SUBJECT: PALISADES NUCLEAR PLANT - ISSUANCE OF AMENDMENT RE: PRIMARY
COOLANT SYSTEM PRESSURE-TEMPERATURE LIMITS (TAC NO. ME5806)

AMENDMENT TO RENEWED FACILITY OPERATING LICENSE

Amendment No. 245
License No. DPR-20

SAFETY EVALUATION BY THE OFFICE OF NUCLEAR REACTOR REGULATION

Figure 3.4.3-1 (Page 1 of 1)
Pressure – Temperature Limits for Heatups
Applicable up to 42.1 EFPY

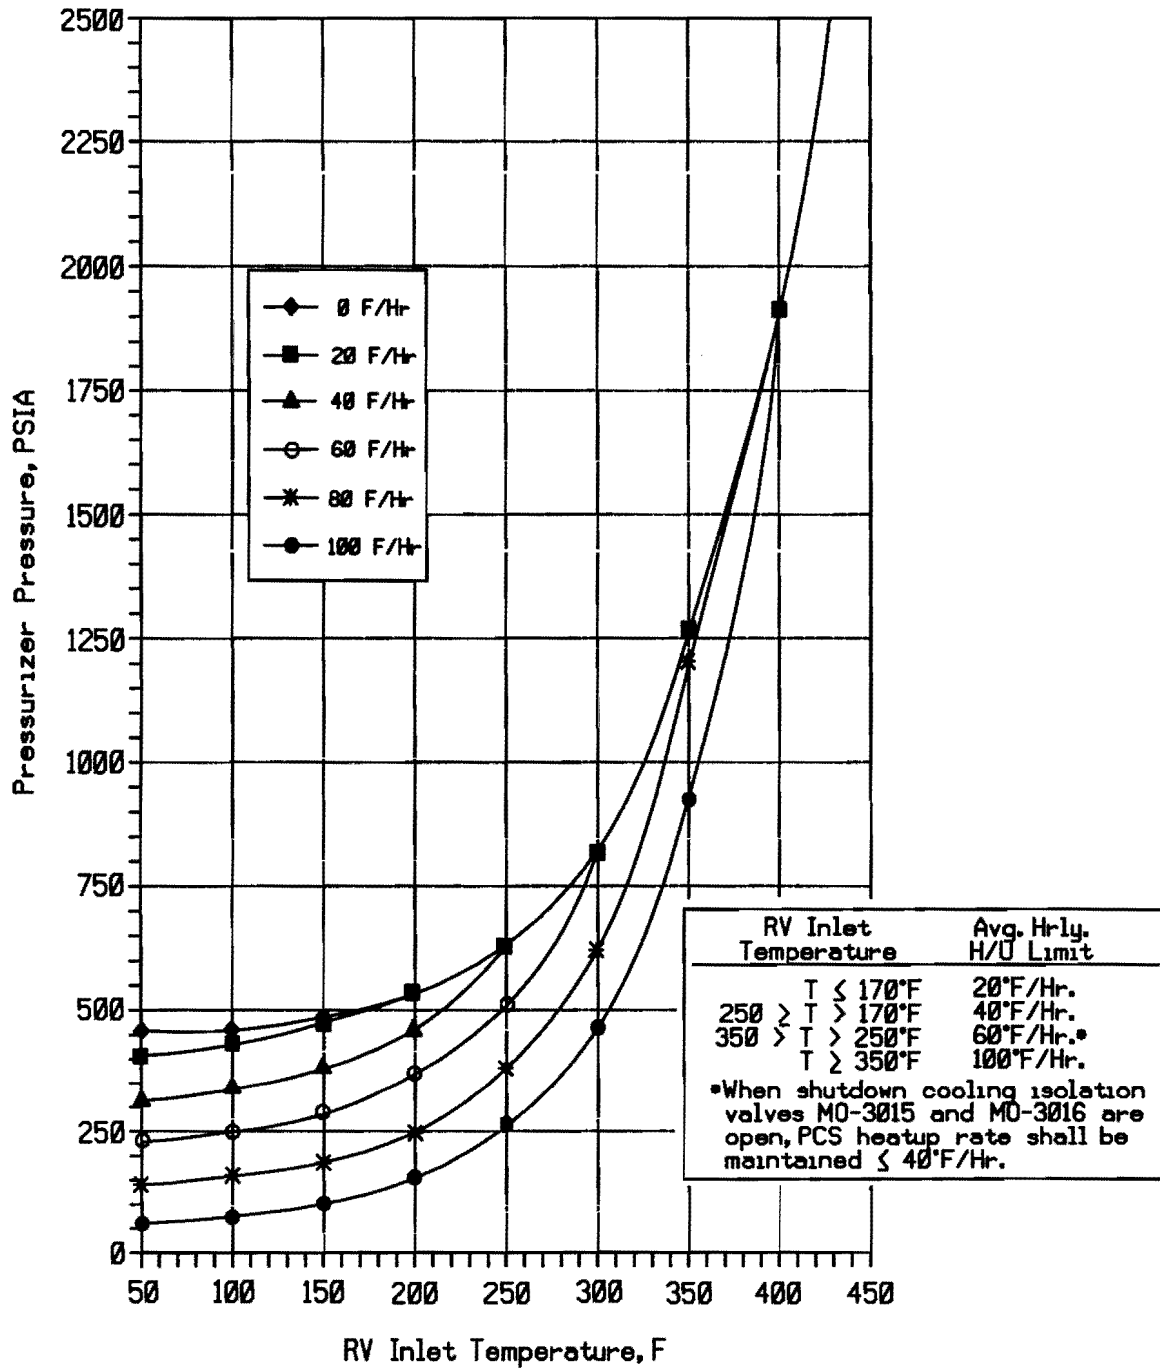
In the submittal, the licensee has shown in WCAP-17341-NP (Attachment 5 to the March 7, 2011 letter) that the current TS curves are more conservative than the new P-T limits. The licensee has chosen to keep the current TS curves and has submitted in the letter dated March 7, 2011, TS changes that add an applicability period of 42.1 EFPY to the following TS figures:

- TS Figure 3.4.3-1, "Pressure-Temperature Limits for Heatups,"
- TS Figure 3.4.3-2, "Pressure-Temperature Limits for Cooldowns," and
- TS Figure 3.4.12-1, "LTOP Setpoint Limit."

The amendment revises the facility's TSs to add an applicability period of 42.1 effective full-power years to the existing pressure-temperature limit curves and low temperature overpressure protection system requirements for PNP.

Figure 3.4.12-1 (Page 1 of 1)
LTOP Setpoint Limit
Applicable up to 42.1 EFPY

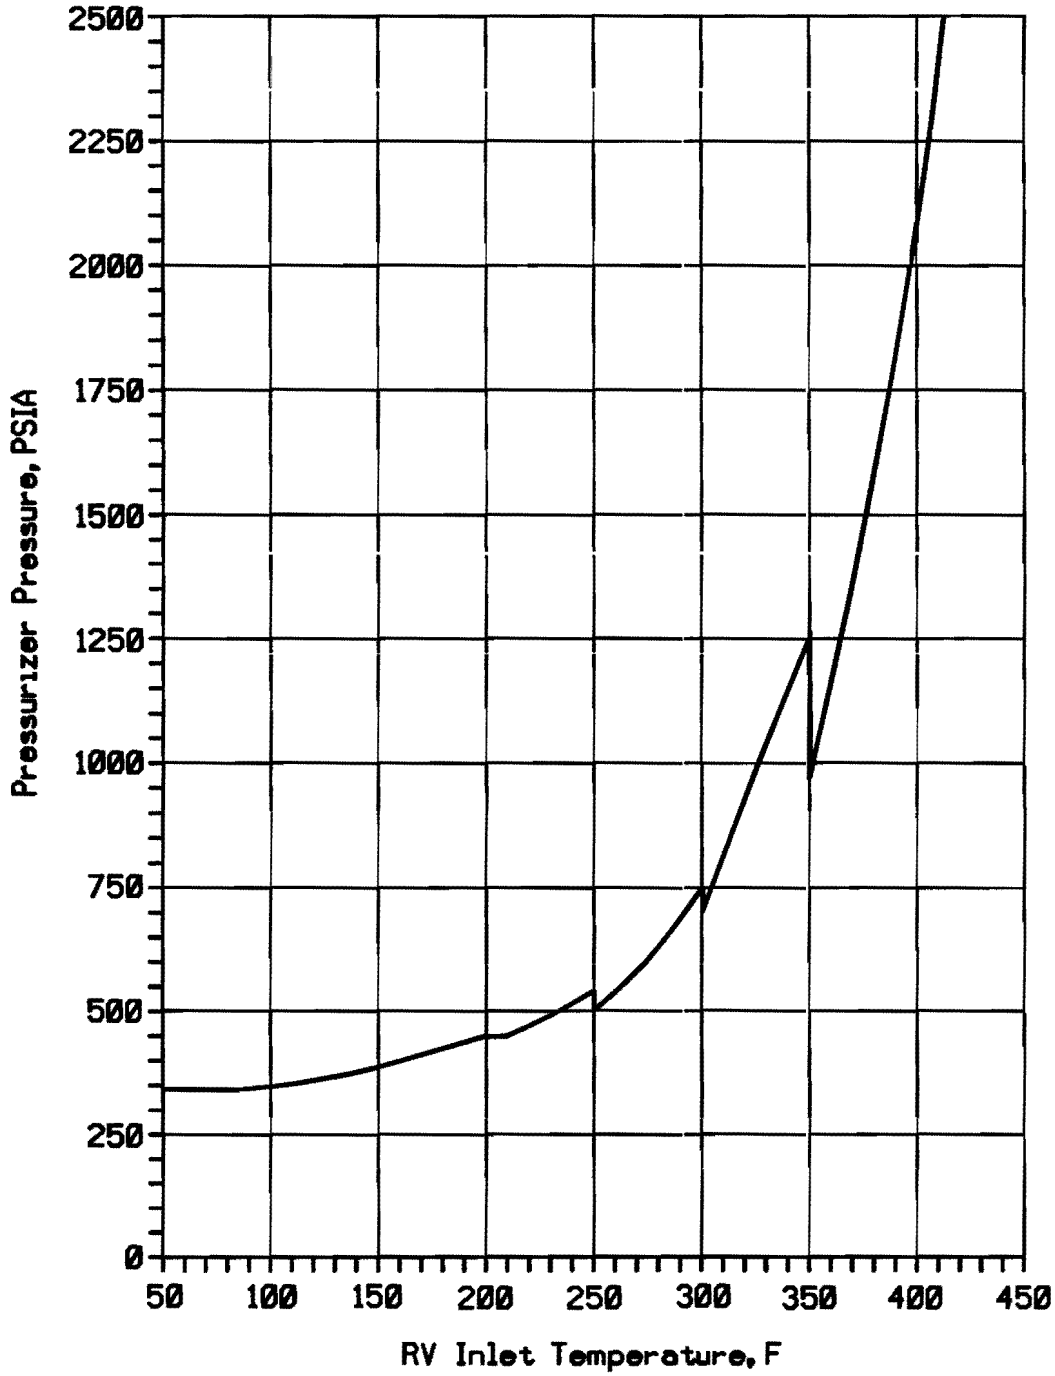
The NRC staff reviewed the LTOP analysis contained in Appendix B of WCAP-17341-NP using the guidance in ASME Code Case N-641, "Alternative Pressure-Temperature Relationship and Low Temperature Overpressurization Protection System Requirements Section XI Division 1." The new, calculated LTOP enabling temperature is 313.2°F based on the criteria specified in Code Case N-641. The current LTOP enabling temperature is applicable when any system cold leg temperature is below 430°F, i.e., more conservative than the new value that is calculated in WCAP-17341-NP. The LTOP setpoint is unaffected by this proposed license amendment, and remains at 315 pounds per square inch absolute. Therefore, the NRC staff agrees that the current LTOP enabling temperature is more conservative and concludes that the requested addition of the 42.1 EFPY applicability period to the LTOP curve is acceptable.
